IR Text Comment Value	Label Value
Location Upstairs Large Elec Room	IR: Date Of Creation 06-12-05
Designation Pnl 220B	IR: File Name IR_120506_017.JPG
Component 100A Breaker	Ar1: Max 61.6 °C
Fault warm Line Side Connection	
Recommendations Remove brk, clean connection, re-install, re-scan

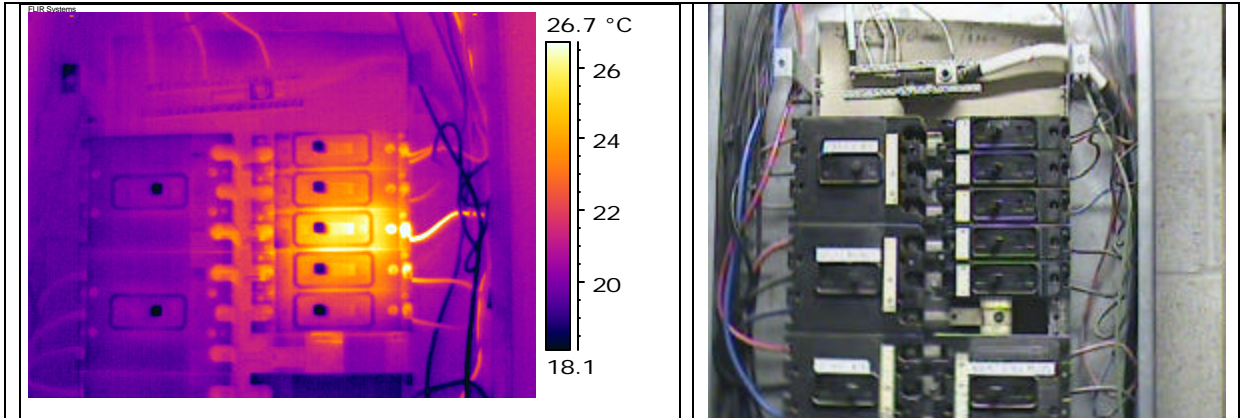
IR Text Comment Value	Label Value
Location Upstairs Large Elec Room	IR: Date Of Creation 06-12-05
Designation Panel 100	IR: File Name IR_120506_023.JPG
Component 15A Breakers	
Fault Overloaded Circuits	
Recommendations See comments below

Single pole 15amp breakers appear to be un-balanced. Couple of these single pole breakers have 18amps on them. The neutral conductor has 15amps on it. The top right breaker was in the tripped position when we found it.

Trace out circuits and re balance loads.
